Product Advisory

Issue Date: 24-August-2023

Change bundling material for TUBE and TRAY from using rubber band to ESD Conductive Grid Tape.

Packaging	Current Packaging: Rubber Band	New Packaging: ESD Conductive Grid Tape
TUBE with vacuum seal		
TUBE		
TRAY

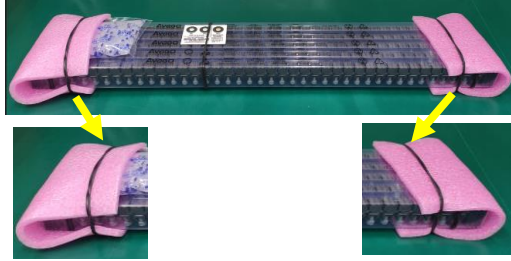
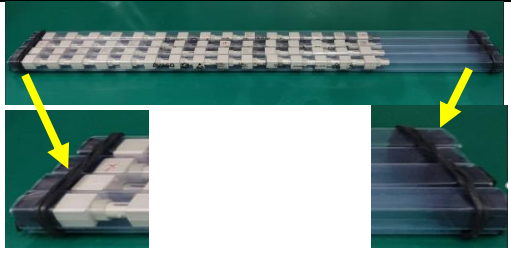
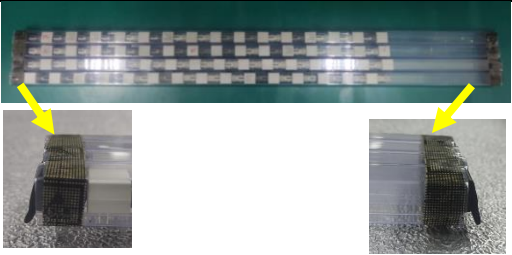
Change bundling material for TUBE and TRAY from using rubber band to ESD Conductive Grid Tape as below photo example.

To reduce the risk of TUBE and TRAY deformation.
